**ZONING AMENDMENT,  
PLANNING APPROVAL &  
SUBDIVISION STAFF REPORT****Date: June 2, 2011**

<b><u>NAME</u></b>	Alabama Realty Company, Inc.
<b><u>SUBDIVISION NAME</u></b>	Alabama West Subdivision, Unit Four
<b><u>LOCATION</u></b>	2600 McVay Drive North (North side of McVay Drive North, 290'± West of Navco Road).
<b><u>CITY COUNCIL DISTRICT</u></b>	District 4
<b><u>PRESENT ZONING</u></b>	R-1, Single-Family Residential District
<b><u>PROPOSED ZONING</u></b>	B-3, Community Business District
<b><u>REASON FOR REZONING</u></b>	To allow the construction and use of a cellular communications tower.
<b><u>AREA OF PROPERTY</u></b>	1 Lot / 1.1 Acres ±
<b><u>CONTEMPLATED USE</u></b>	<p>Subdivision approval to create one legal lot of record from a portion of an existing metes-and-bounds parcel, Planning Approval to allow the construction and use of a 130' monopole communications tower in a B-3, Community Business District, and Rezoning from R-1, Single-Family Residential District, to B-3, Community Business District, to allow the construction and use of a cellular communications tower.</p> <p><b>It should be noted, however, that any use permitted in the proposed district would be allowed at th

## SUBDIVISION AND ZONING DETAIL

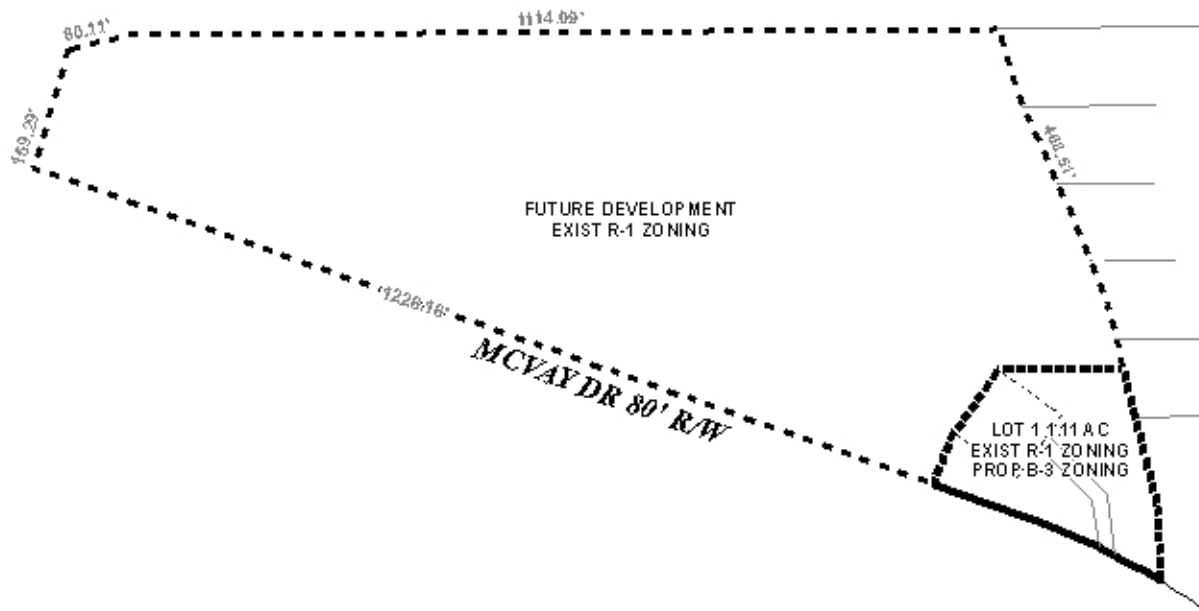
- 2) revision of the plat to illustrate the 25' minimum building setback line along McVay Drive North;
- 3) revision of the plat to label the lot with its size in square feet and acres, or the furnishing of a table on the Final Plat providing the same information;

- 4) labeling of the Future Development area as such on the final Plat;
- 5) placement of a note on the Final Plat stating that the approval of all applicable federal, state and local environmental agencies would be required prior to the issuance of any permits or land disturbance activities; and

- 1) placement of a note on the Final Plat stating that the driveway number, size, location and design are to be approved by Traffic Engineering and conform to AASHTO standards;*
- 2) revision of the plat to illustrate the 25' minimum building setback line along McVay Drive North;*

- 3) *revision of the plat to label the lot with its size in square feet and acres, or the furnishing of a table on the Final Plat providing the same information;*

- 4) *labeling of the Future Development area as such on the Final Plat;*
- 5) *placement of a note on the Final Plat stating that the approval of all applicable federal, state and local environmental agencies would be required prior to the issuance of any permits or land disturbance activities; and*

# SITE PLAN

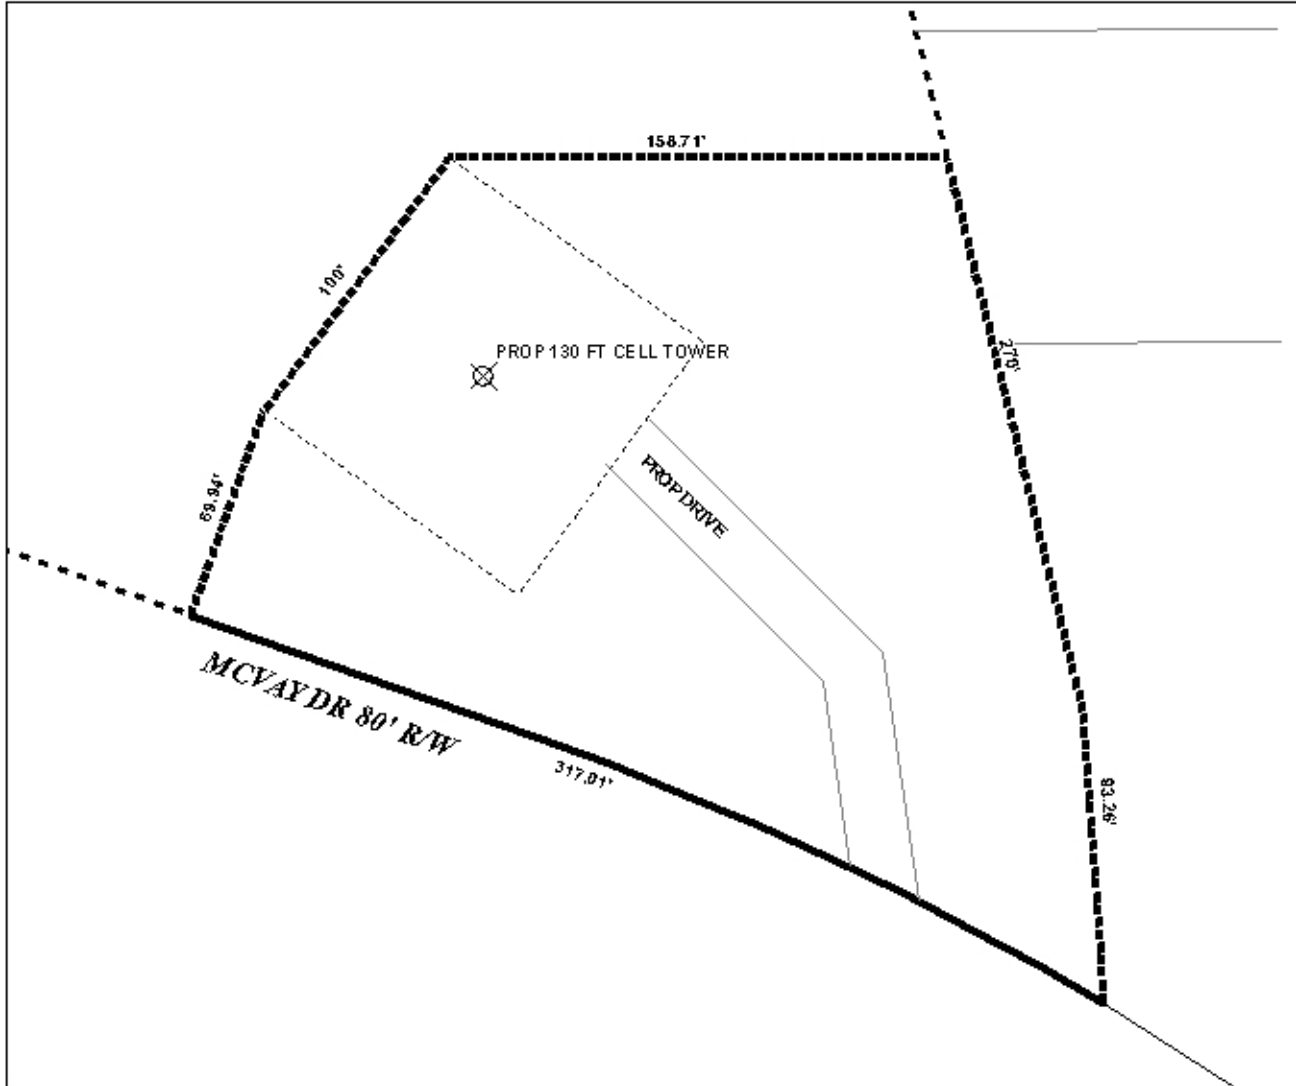
- 8) subject to the approval of all required variances associated with the proposed 140' over-all high tower;*
- 9) placement of a note on the site plan stating that clearing of the site is limited to the area necessary for construction of the compound and access road and the remainder of the site is to remain in its natural vegetative state; and*

- 10) submittal to Planning of a more detailed site plan showing all conditions of approval of the Planning Approval and any required variances prior to the application for land disturbance and construction permits.*
